# Ivanhoe Estate

## Redevelopment Stage 1

### Modification 6

Minor increase in height of Building A1  
State Significant Development Modification Assessment  
(SSD 8903 MOD 6)

**Figure 4 |** Proposed roof plan (Source: Bates Smart)

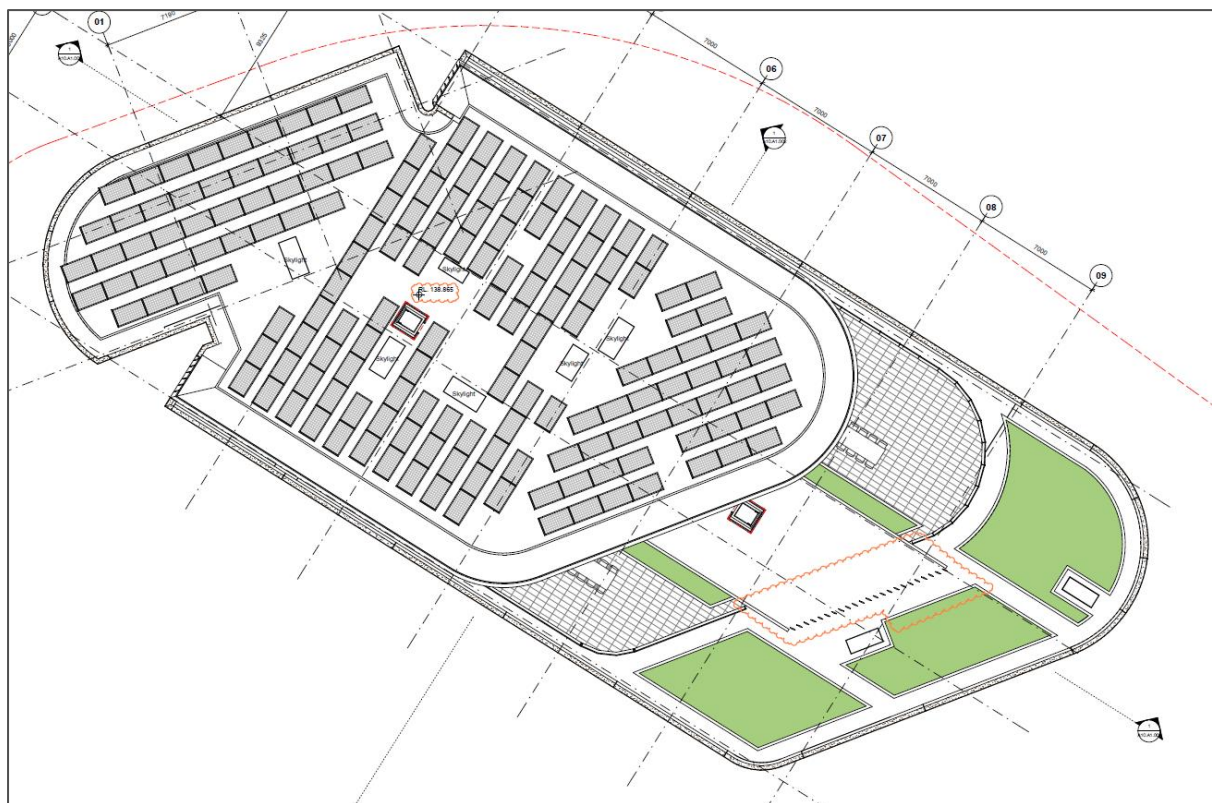
The modification application seeks approval for an increase to the height of Building A1 by a total of 565mm, resulting in a maximum building height of 75.365m (RL 138.865). A 295mm change to the maximum approved parapet height is additionally sought, from RL 138.8 to RL 139.095.

The approved 25 storey building has a lower ground and ground floor level, before numbered levels begin, with Level 23 forming the topmost storey. The proposal will result in a 0.215m increase to the height of the finished floor levels of Levels 21 and 22 and a 0.135m increase to Level 23, effectively altering the height of the top 3 levels of the building.

**Figure 6 | Section AA depicting proposed roof height RL and changes to ceiling heights (Source: Bates Smart)**

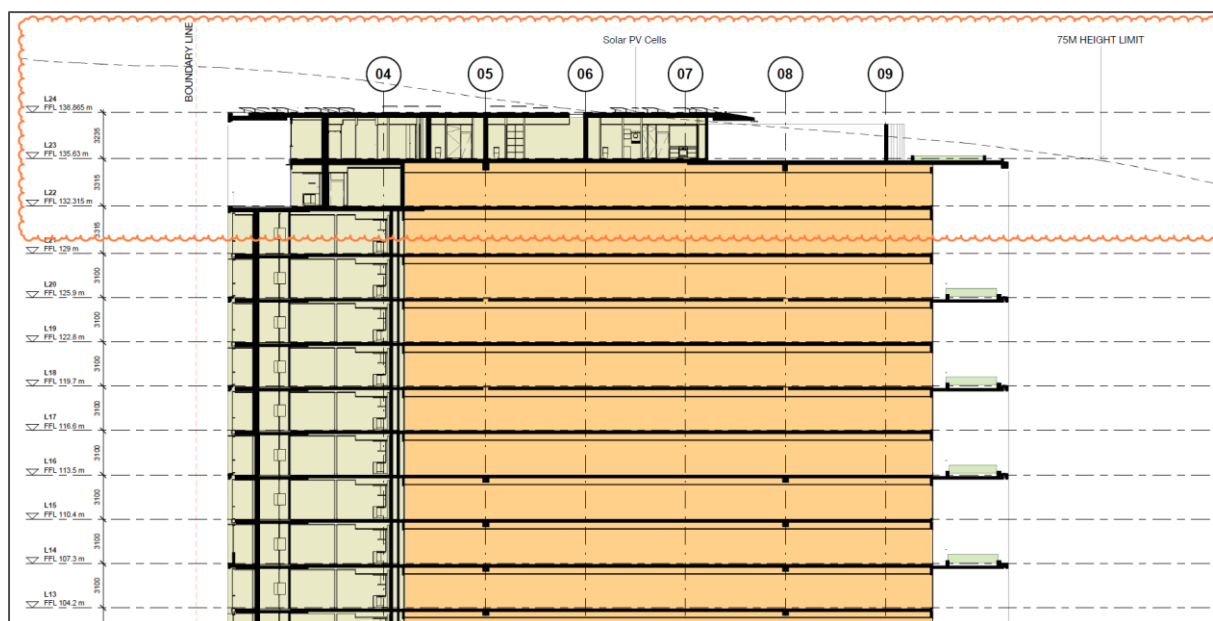
The Applicant contends the extra height is required for additional structural and insulation works, that are mandated by post-approval revisions to the NCC. As per the Applicant's advice, there will be no change to the floor to ceiling heights in the development.

**Figure 7 | 9:00am Summer Solstice shadow diagram (Source: Bates Smart)**

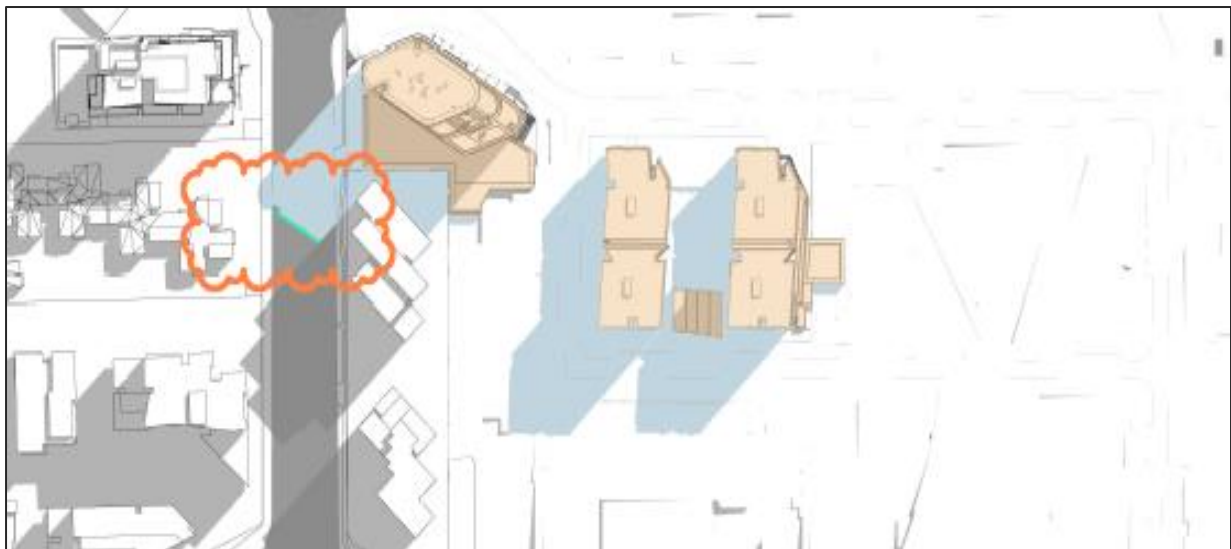
The proposal would result in a minor increase in overshadowing in the morning (9am to 10am) period during the summer solstice and the equinoxes. However, the shadows are mainly cast on Herring Road and do not result in any adverse impacts to adjoining residences or open space (**Figure 7**). Given the orientation of the site, the affected areas enjoy solar access unimpeded by the development, after the 10am period.

**Figure 8 | 3:00pm Summer Solstice Shadow Diagram (Source: Bates Smart)**

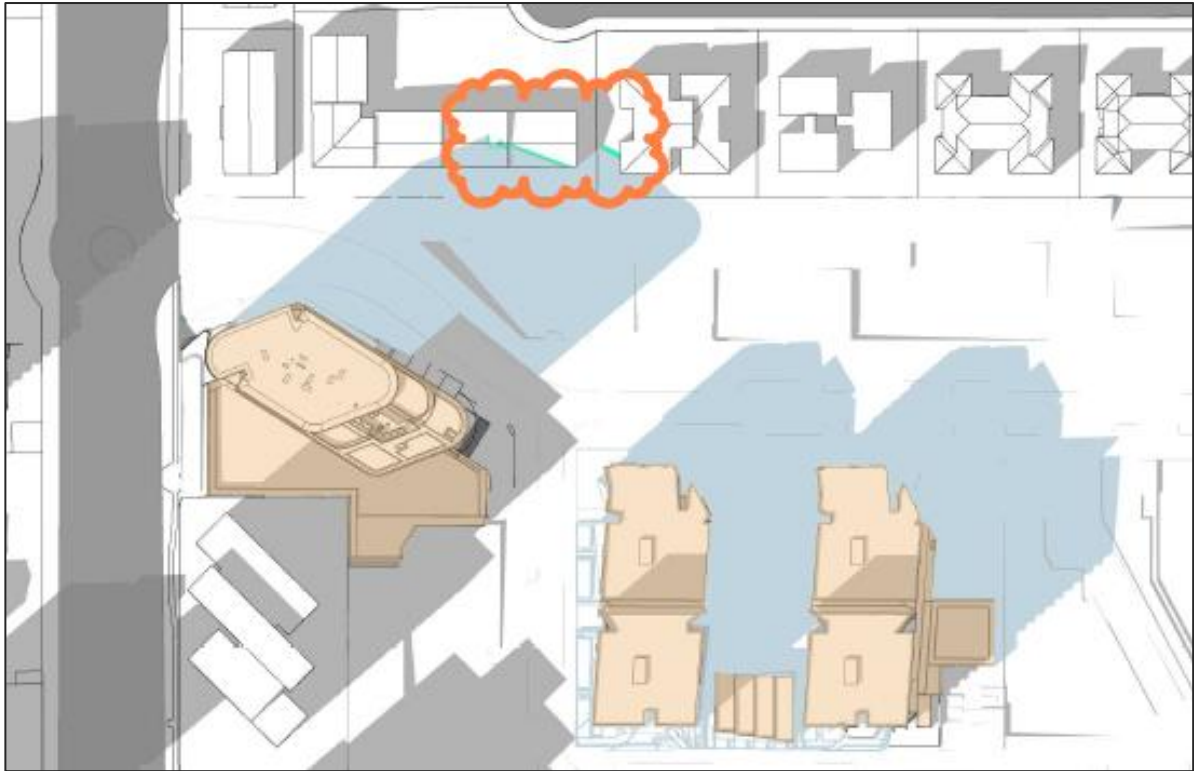
The Department notes there is a slight increase in overshadowing in the afternoon 3pm period, to the developments along Peach Tree Road (**Figure 8**). The shadows are minor and mainly fall against the roof and a small portion of the rear open space. The Department accepts these spaces receive solar access unimpeded by the development up until this point and considers that given the minor impacts, the proposal is acceptable in this instance.

**Figure 11 | 11:00am Winter Solstice shadow diagram (Source: Bates Smart)**

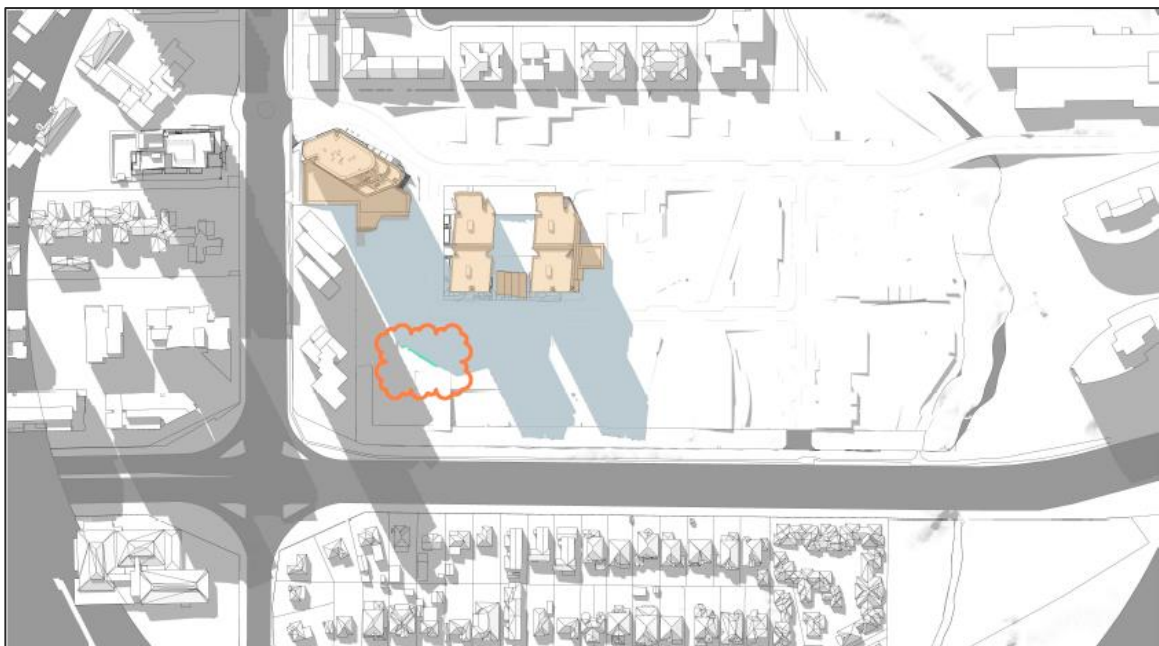
During the winter solstice period, when shadowing impacts are potentially most significant, a minor increase in the shadows cast by the development is shown during the 9am-11 am period (**Figures 9 - 11**). Nonetheless, the potentially affected areas (to the south and east) are currently overshadowed by the 22 storey residential towers at 137-143 Herring Road, directly south-west of Building A1.

As is evident in **Figures 9 and 11** the additional solar impacts fall mainly within the site. Given that the height change is minor (565mm), the increase in overshadowing is correspondingly minimal. The 9am period sees a slight increase in overshadowing towards Epping Road, but this area already experiences overshadowing from the towers at 137-143 Herring Road. The shadows then move within the site and across residential Building D1 (10am -12pm) before falling across a portion of Building C4 and the access road (3pm).

The Department notes the additional solar impacts fall mainly within the site and do not unreasonably affect residential areas or open space. The Department therefore considers surrounding development both within and outside the site would still retain an acceptable amount of solar access consistent with the outcomes envisaged in the original application and the concept approval.

**Figure 13 |** Photomontage of Concept Plan of development looking south-west (Base Source: Department's SSD 8707/8903 Assessment Report)

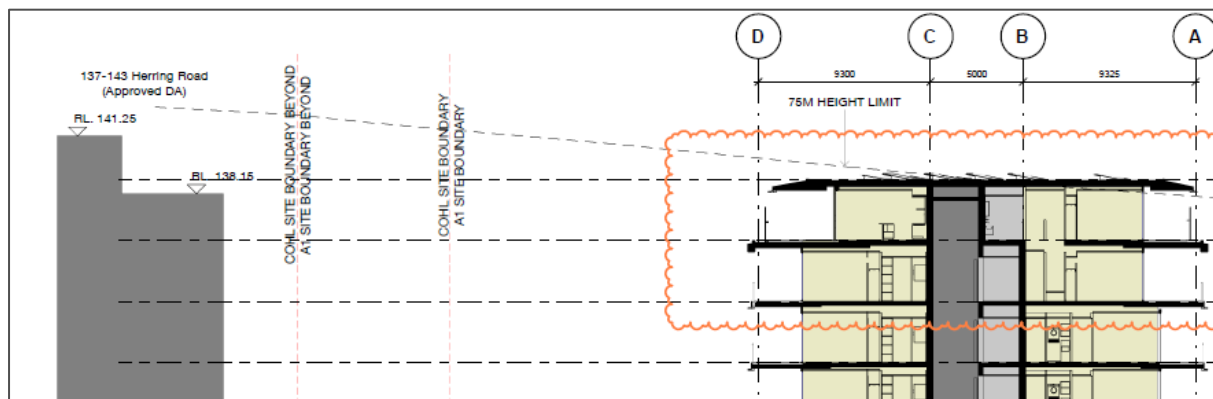
The Department notes that Building A1 has an approved height that is greater than the immediately adjacent buildings within the site, including Buildings A2 (45m), B1.1 (45m), C1 (45m-65m). As such, the proposed variation would have little impact on the views enjoyed by these buildings, given that they would not have a view corridor that passes through levels 21-23.

**Figure 14 |** Section detailing the relationship and RLs of the tower at 137-143 Herring Road to the proposed development (Source: Bates Smart)

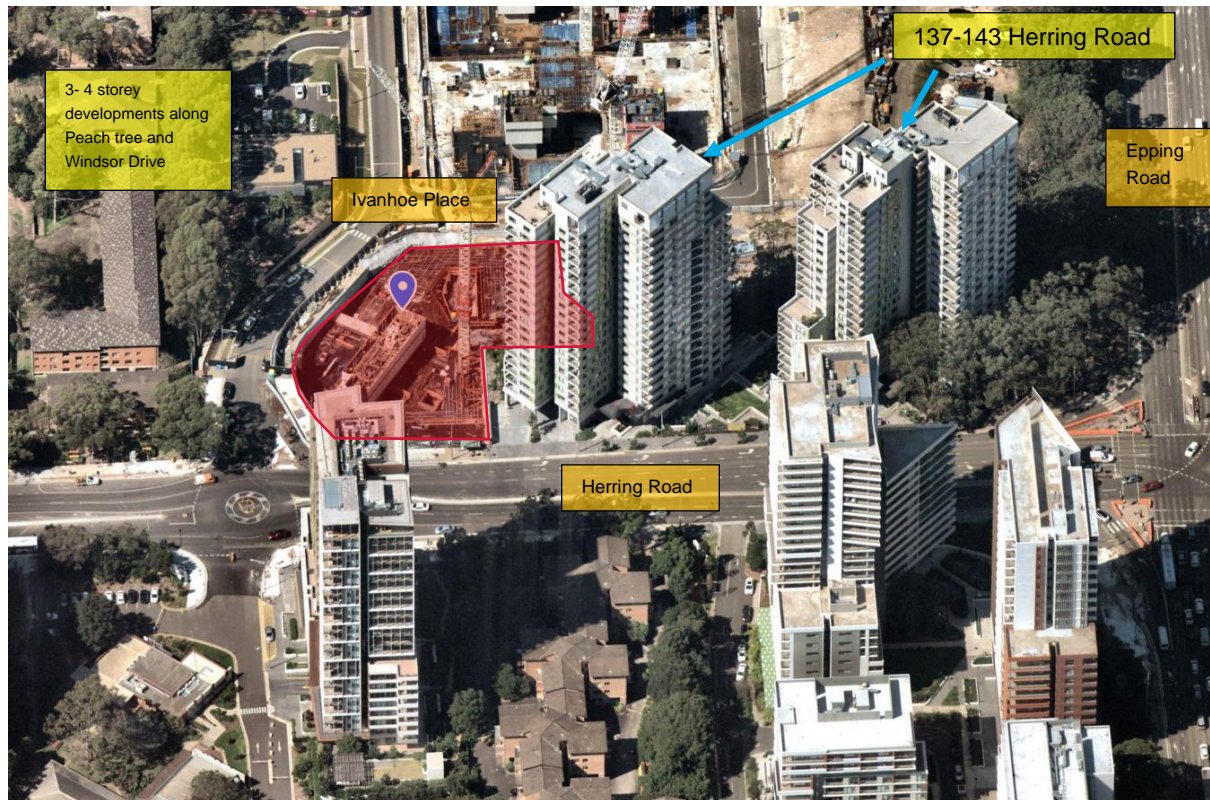
Similarly, the top storey of the northern-most tower at 137-143 Herring Road would not experience any loss of views as the existing height of Building A1(RL 138.3) sits above the upper residential level (RL138.15) (**Figure 14**). The proposed increase (RL 138.865) may affect a small portion of the upward outlook to the sky at the uppermost levels but will not block any iconic or scenic views. The affected development would still enjoy panoramic views of the surrounds due to its height and orientation.

Given the above, the Department considers that the potential visual and view loss impacts of the proposal are minor and would not compromise views or the amenity of the surrounding residences.
